To: Public Works Department

From: Milwood Neighborhood Association

Subject: Northern Walnut Creek Trail connection between Segments 2 and 3

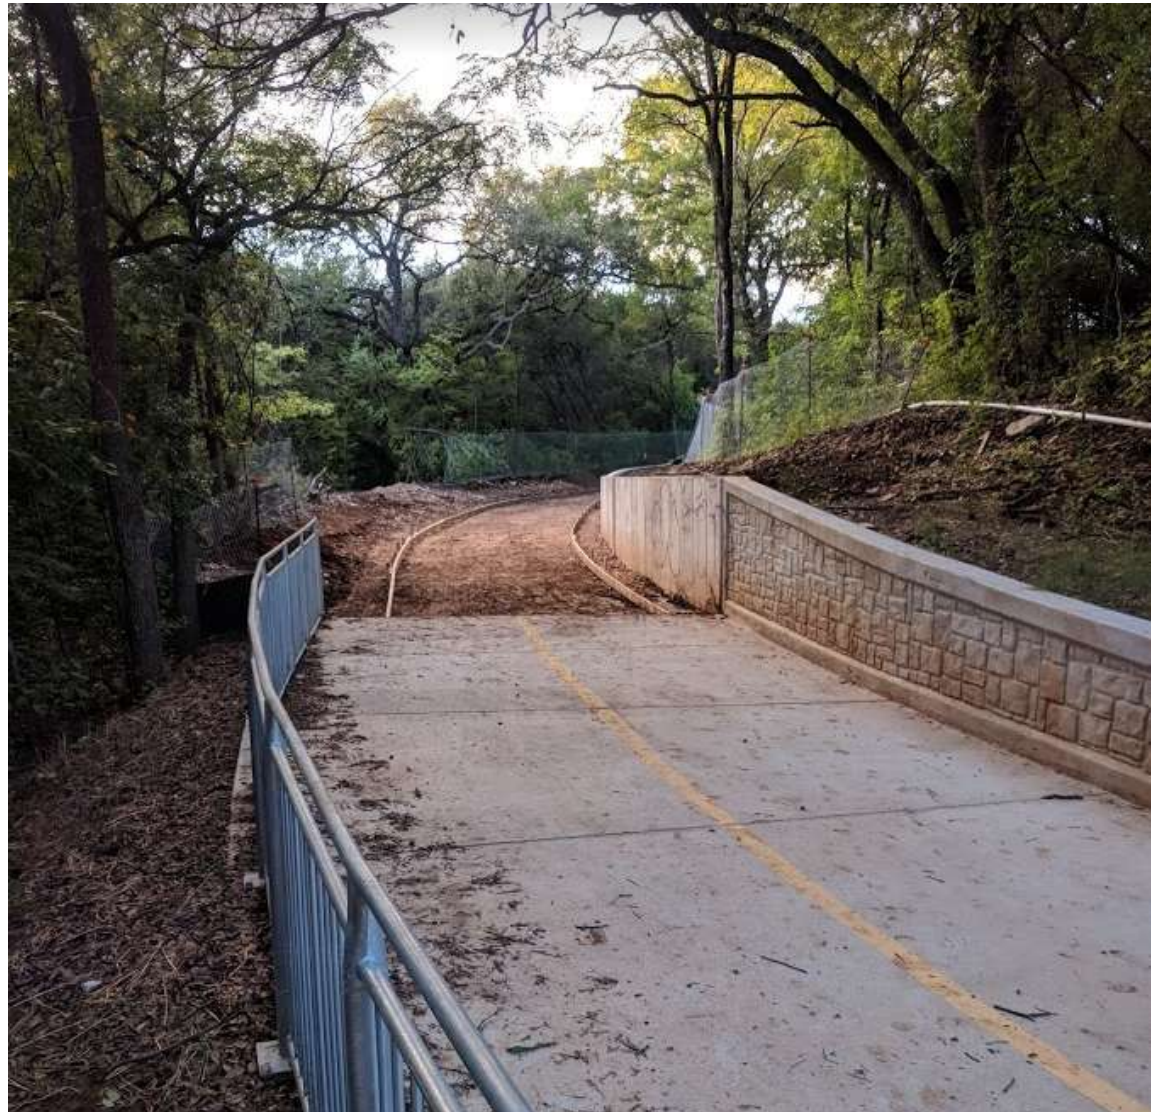
Upon questioning the form placement shown in the photo here, Milwood Neighborhood Association (MNA) contacted Public Works staff and was informed that the transition to between the existing Segment 2 trail and new Segment 3 will consist of an abrupt transition from the existing 14' wide concrete surface to 10' with 2' compacted base shoulders.

MNA is concerned that either select fill, or native soil, or compacted base will erode and be deposited on the trail surface causing hazards to trail users. There is already a problem with material being deposited on the completed Segment 2 immediately downhill of this location. We are also concerned that differential settlement of soil or base material and the concrete surface will create a ledge at the transition.

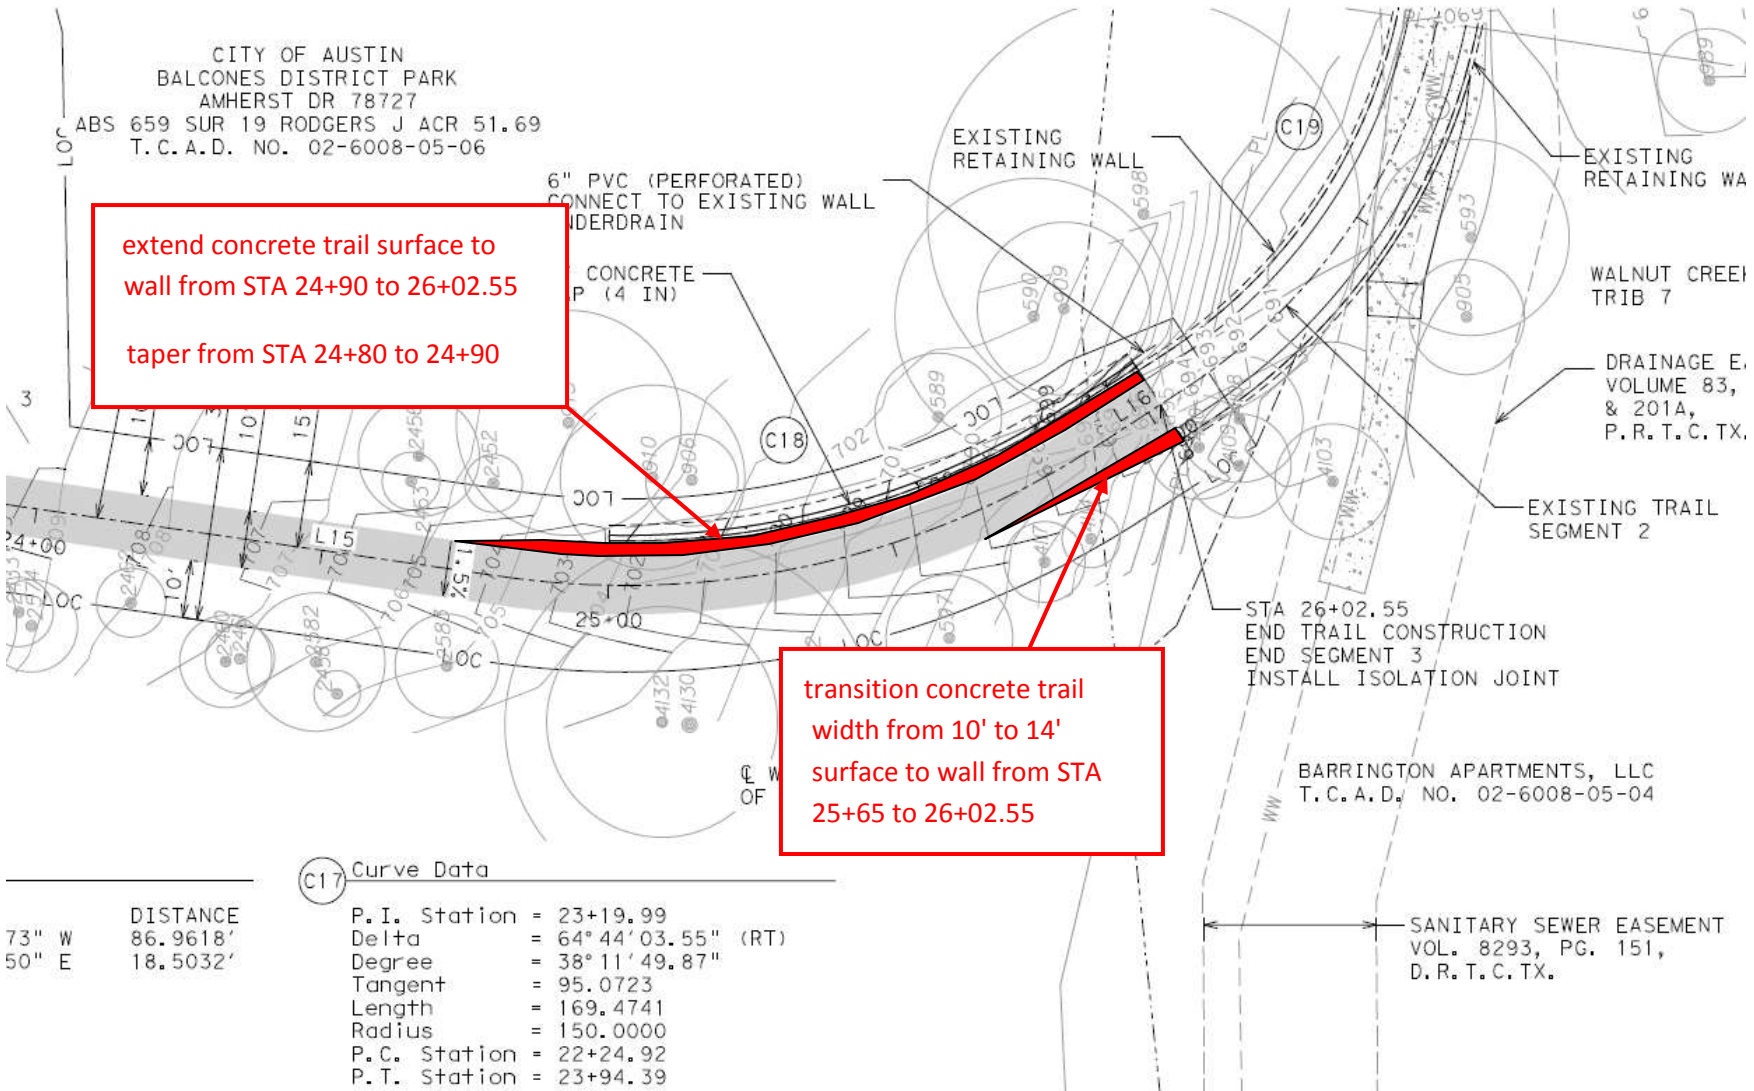
- 1) MNA requests that the concrete surface be extended to cover the 2' between the trail and wall and that the outside of the trail be backfilled with native soil and revegetated. We recommend that the concrete surface be extended approximately 10' beyond the end of the wall to allow runoff flowing to the trail to pass over the trail. The additional concrete required is approximately 30 sy which is an additional material cost of approximately \$1212, not including compensation for resetting forms. We request the City authorize a change order to fulfill this request.

extend concrete trail surface to wall from STA 24+90 to 26+02.55  
 taper from STA 24+80 to 24+90

transition concrete trail width from 10' to 14' surface to wall from STA 25+65 to 26+02.55

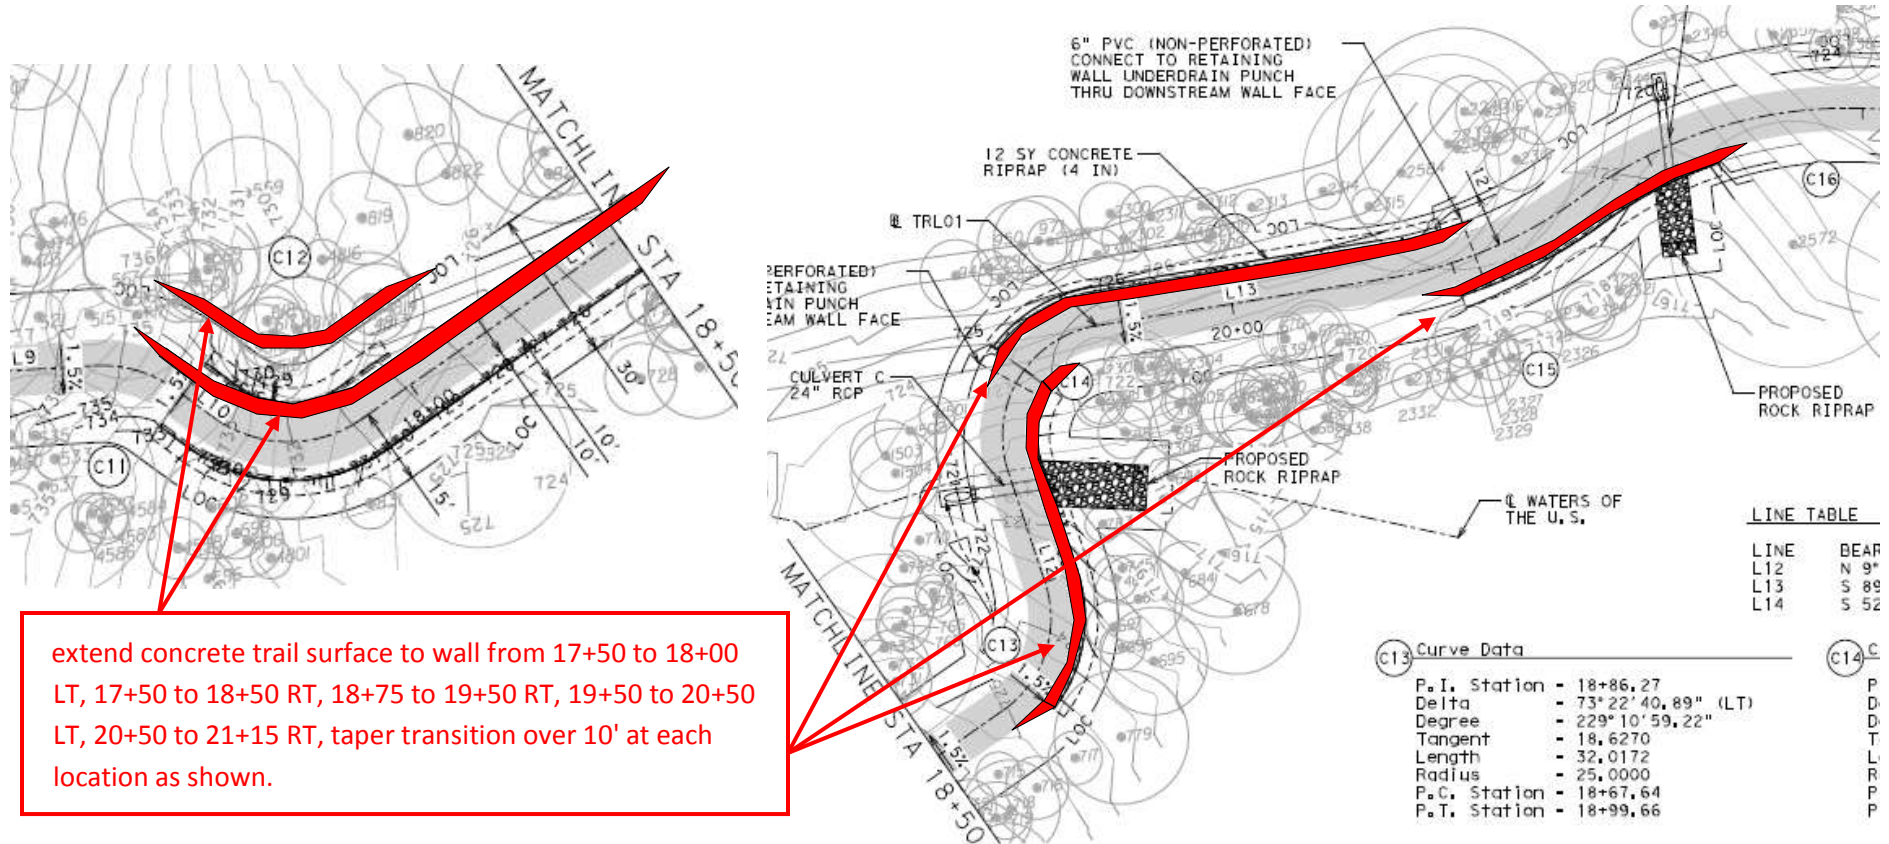
- 3) We request the city consider extending the concrete surface to the retaining wall in other areas where a retaining wall is proposed (17+50 to 18+00 LT, 17+50 to 18+50 RT, 18+75 to 19+50 RT, 19+50 to 20+50 LT, 20+50 to 21+15 RT). This additional 98 sy would cost approximately \$3911.

extend concrete trail surface to wall from 17+50 to 18+00 LT, 17+50 to 18+50 RT, 18+75 to 19+50 RT, 19+50 to 20+50 LT, 20+50 to 21+15 RT, taper transition over 10' at each location as shown.
